# METROPOLITAN GOVERNMENT OF NASHVILLE AND DAVIDSON COUNTY

## STAFF RECOMMENDATION 222 3<sup>rd</sup> Avenue North April 15, 2015

**Application:** New construction-addition; Alterations  
**District:** Second Avenue Historic Preservation Zoning Overlay  
**Council District:** 19  
**Map and Parcel Number:** 09302315900  
**Applicant:** Brent Houck, AIA  
**Project Lead:** Robin Zeigler, robin.zeigler@nashville.gov

ENLARGED SOUTH ELEVATION (ROOFTOP) - WEST | 2  
 1/8" = 1'-0" | A-43

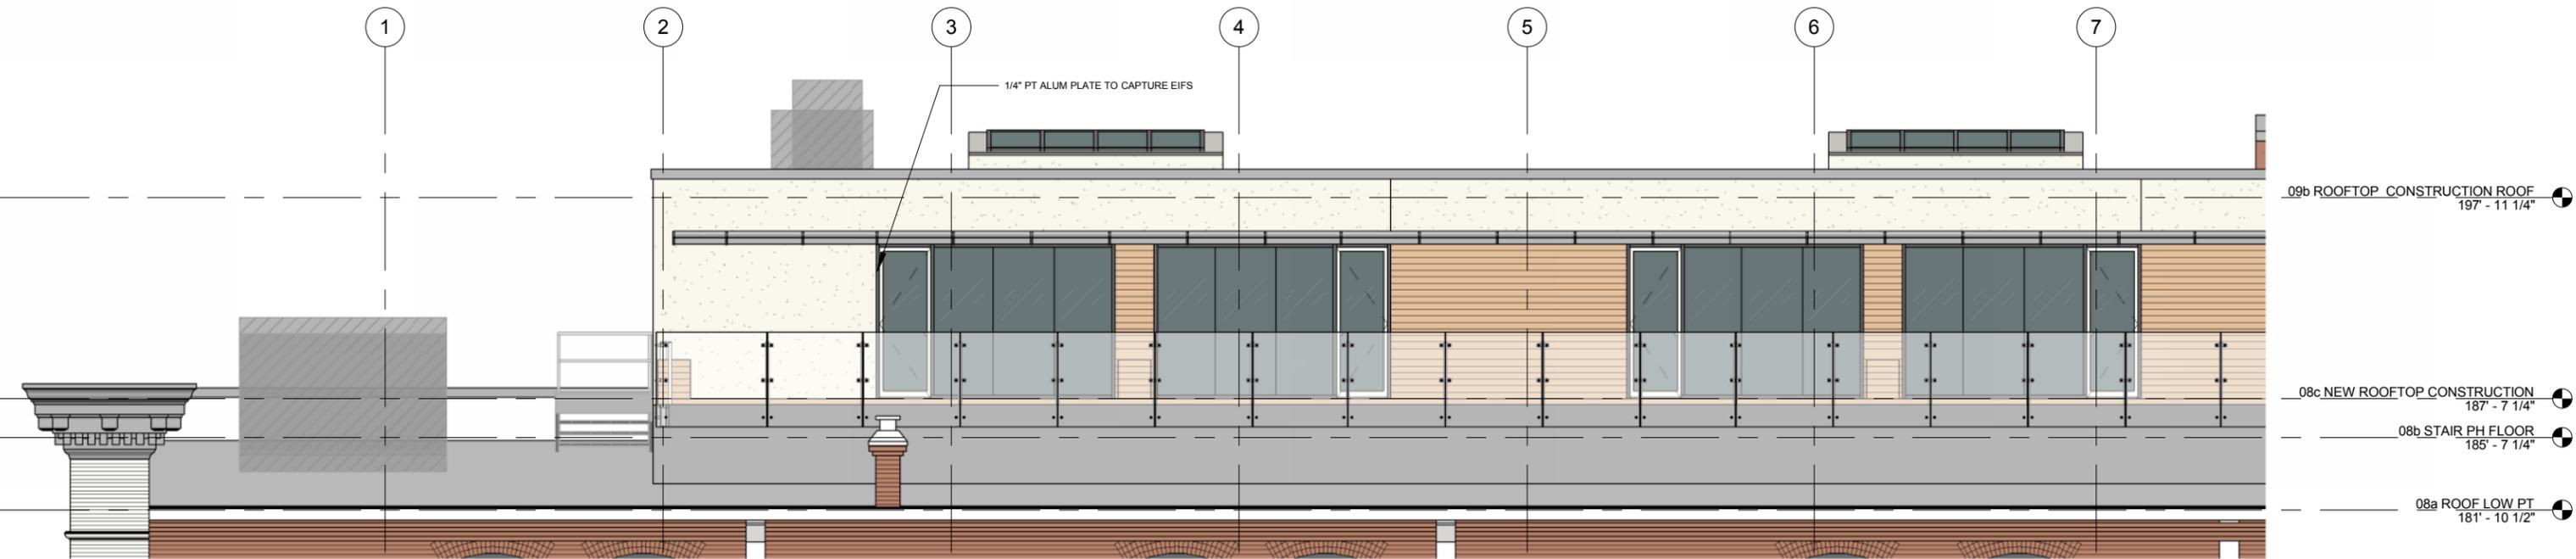
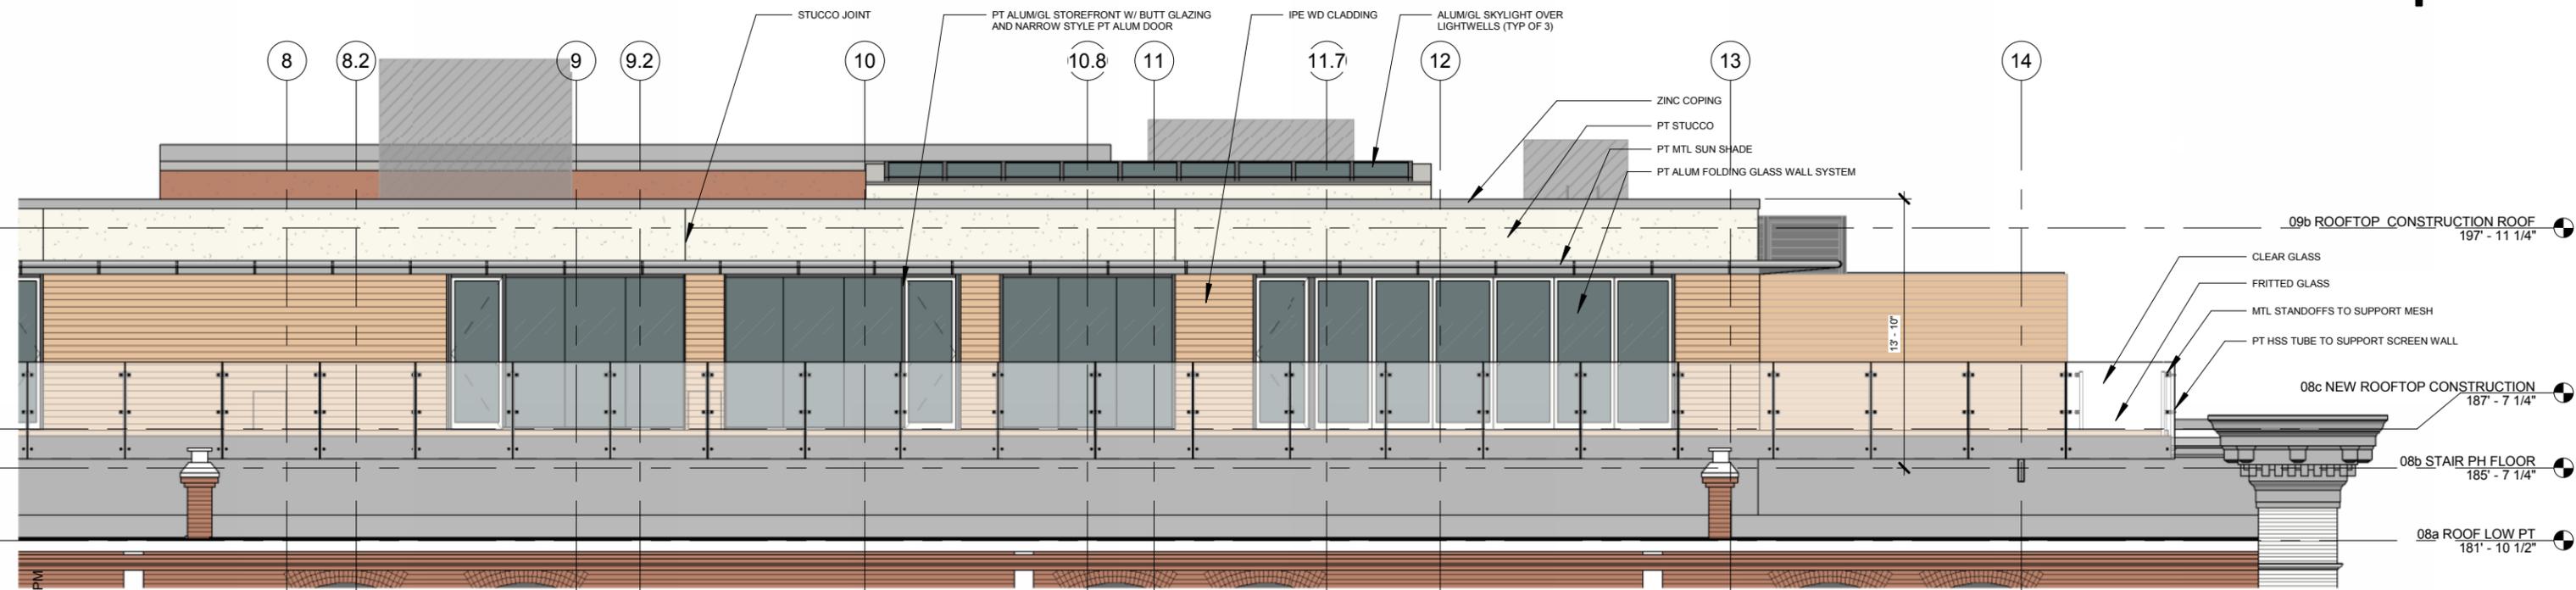
**Addition/Setbacks:** The rooftop addition meets the minimum thirty-foot (30’) setback from Third Avenue. The majority of the addition meets the minimum thirty-foot (30’) setback from Second Avenue. The stair enclosure, which is approximately twenty-two feet (22’) wide, compared to the overall width of approximately fifty-six feet (56’), is only sixteen feet (16’) from the front wall on Second Avenue. At its tallest point, the stair enclosure is approximately eight feet (8’) taller than the parapet wall on Second

Avenue. Staff finds this to encroachment into the setback area to be appropriate due to the height of the building and the minimal width and height of the stair enclosure.

Including the projecting canopy of the addition, the alley-side setback is fourteen feet (14'). The design guidelines do not specify an alley-side setback but they do require at least twenty-feet (20') from a secondary street. Since this is just an alley, which is narrower than a street and because of the height of the building, staff finds that the setback will result in the addition being minimally visible from the public right-of-way. The railing on the alley-side sits back the eight feet (8') required by the design guidelines.

**Addition/Height:** The height of the addition varies. The bulk of it is approximately twelve feet (12') tall from the parapet wall, which is below the maximum of fifteen feet (15') allowed by the design guidelines. Portions of the addition, primarily mechanicals, extend as much as eighteen feet (18') from the parapet wall. Because these intrusions are small in scale and sit further back from the parapet wall than the primary wall of the addition, and because of the tall height of the building, which will minimize views of the addition, staff finds the additional height to be appropriate.

**Addition/Materials:** The cladding materials for the rooftop addition include part stucco and parged CMU and IPE wood cladding with zinc coping. IPE has only been allowed as an accent material. Since the addition will likely not be visible, Staff finds it is an appropriate material in this situation. Openings will have an aluminum folding glass wall. The rooftop will include aluminum skylights, a metal sunshade and clear glass railing. One elevation mentions EIFS, which is inappropriate and not been allowed on past projects.

- Applicant seeks administrative approval of materials and methods for cleaning and repair of masonry;
- No lighting be integrated into awnings;
- Applicant seeks administrative approval of materials to replace the items on the plan shown as EIFS and Krion.
